**Physical Disability Australia Ltd**  
**P O Box 38**  
**Willawarrin NSW**  
**Australia 2440.**

Committee Secretary  
House of Representatives Standing Committee on  
Legal and Constitutional Affairs  
PO Box 6021  
Parliament House  
CANBERRA ACT 2600 AUSTRALIA  
E-mail: [laca.reps@aph.gov.au](mailto:laca.reps@aph.gov.au)

Physical Disability Australia would like to thank the committee for the opportunity to comment on the Draft Disability (Access to Premises – Buildings) Standard as set out in this document.

### **Platform area:**

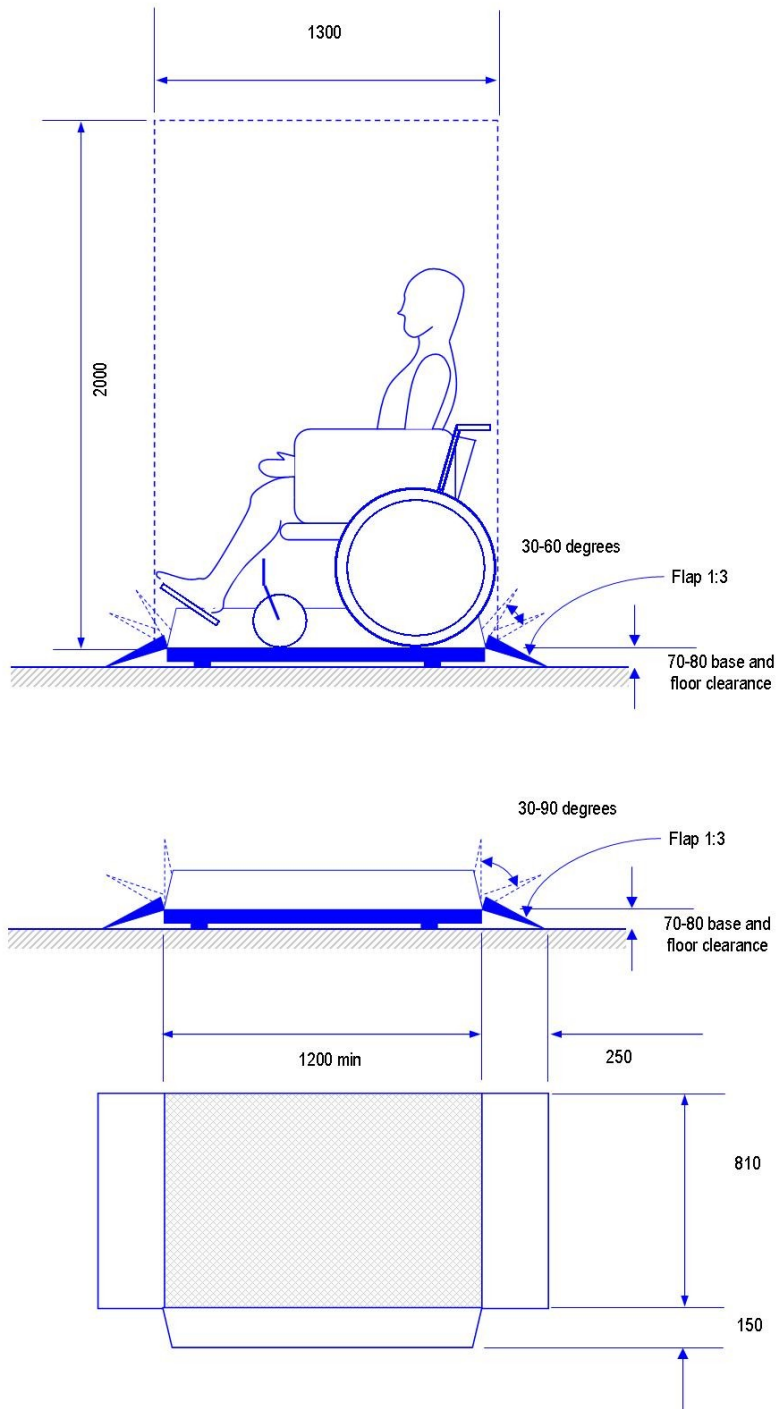
Table 1 requires the minimum platform dimensions to be 685mm wide x 1000mm long. However the draft DDA Premises Standard requires the minimum platform size for stairway lifts in public buildings to be 810mm wide x 1200mm long. It is recommended therefore that Table 1 be amended to show the platform minimum dimensions as 1200mm long and 810mm wide. The Note to Table 1 states that length is measured horizontally in the direction of travel between the safety flaps in the elevated position or the sensitive edges in the non-actuated position, whichever applies. The position at which length is measured is not clear to all readers and it is recommended that a Figure be provided to clarify the requirement.

- It is recommended therefore that Table 1 be amended to show the platform minimum dimensions as 1200mm long and 810mm wide.
- It is recommended that a Figure be provided in association with Table 1 to clarify the position at which platform length is measured.

**End Person Clearance:**

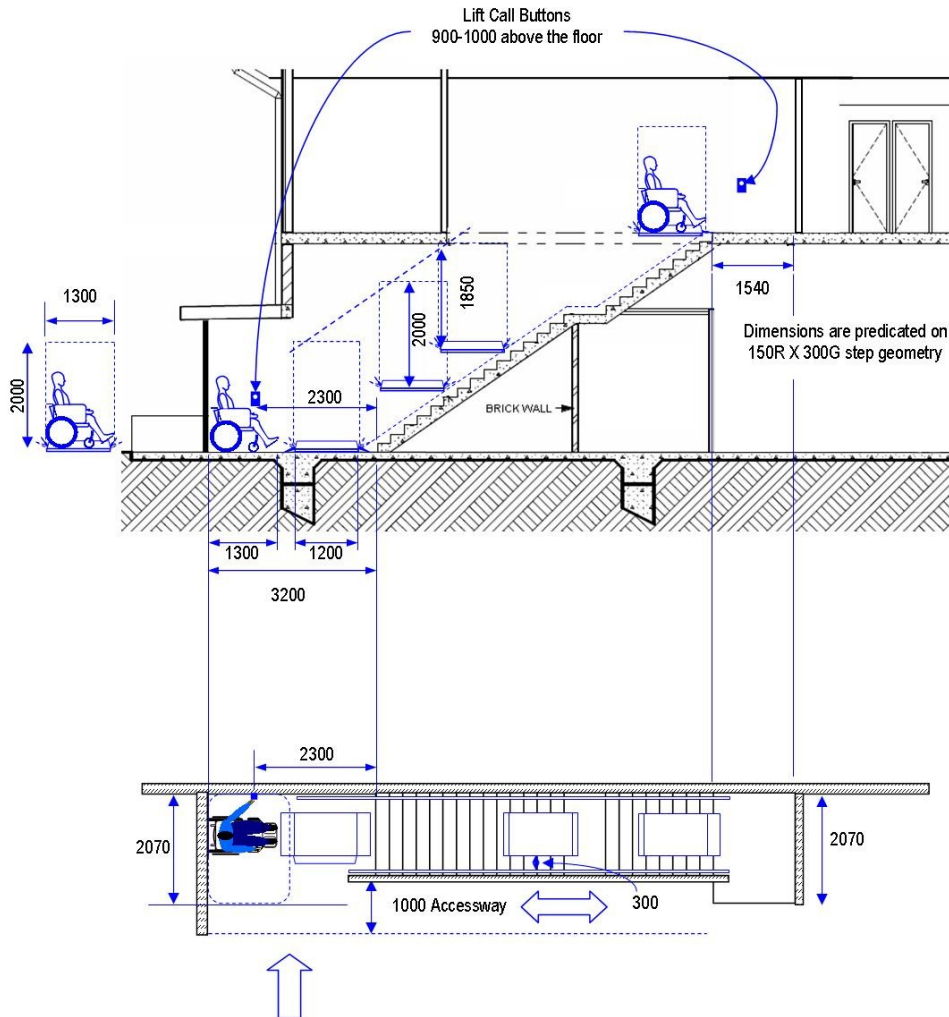
While Clause 14 refers to an end person clearance of 300mm, this clearance does not address the necessary wheelchair circulation space as shown in the figure below required for the bottom landing and the top landing. Access to the platform shall be by end approach only.

- It is recommended that a sub-Clause be added to Clause 14 requiring wheelchair circulation space as shown in the figure below at the bottom

landing and at the top landing for stairway lifts in public buildings.

- It is recommended that a sub-Clause be added to Clause 14 requiring access to the platform to be by end approach only for stairway lifts in public buildings as shown in the figure below.
